Access Compliance Report

Public Rights-of-Way

(Curb Ramps)

Intersection ID: 5196	Main Street: INTERFACE_LN	Cross Street: KRYSTLE_JUNE_BV	Location:	N
ADA ID: 595C3CEAA335	Ramp Type: Perp	Initial Pass/Fail: Fail	Overall Compliance: No	Severity Score: 8.75
Codes/Mitigation Info/Possible Solution		Field Measurements/Component Compliance

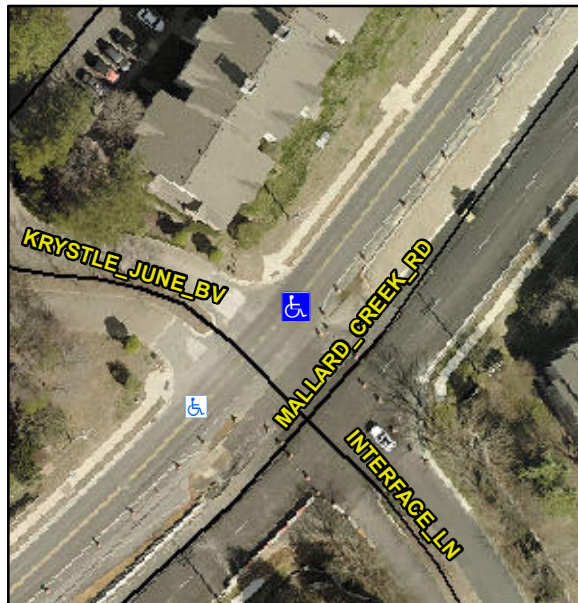
Not Found, R304.5.1

Compliance	Description	Data	Compliance	Description	Data
N/A	Ramp Length (in)	104.0	Yes	Ramp Slope (%)	6.3
No	Ramp Width (in)	43.0	Yes	Ramp XSlope (%)	0.8
N/A	Flare Type LT	N/A	N/A	Flare Type RT	N/A
N/A	Flare Slope LT (%)	N/A	N/A	Flare Slope RT (%)	N/A
N/A	Flare Traversable LT?	N/A	N/A	Flare Traversable RT?	N/A
N/A	Landing Length (in)	N/A	N/A	DWS Provided?	N/A
N/A	Landing Width (in)	N/A	N/A	DWS Contrast?	N/A
N/A	Landing Slope (%)	N/A	N/A	DWS Length (in)	N/A
N/A	Landing X Slope (%)	N/A	N/A	DWS Full Width?	N/A
N/A	Landing Curb? (Y/N)	N/A	N/A	DWS Offset (in)	N/A
N/A	Shared Landing?	N/A			
N/A	Gutter Ponding?	N/A	N/A	Gutter Slope (%)	N/A
N/A	Gutter Lip Ht (in)	N/A	N/A	Gutter X Slope (%)	N/A
N/A	Painted X Walk1?	No	N/A	Painted X Walk2?	N/A
	X Walk 1 Direction	To SW		X Walk 2 Direction	N/A
N/A	X Walk 1 Width (in)	N/A	N/A	X Walk 2 Width (in)	N/A
	X Walk 1 Slope (%)	1.1		X Walk 2 Slope (%)	N/A
	X Walk 1 X Slope (%)	0.6		X Walk 2 X Slope (%)	N/A

Remove & Replace Entire Ramp.
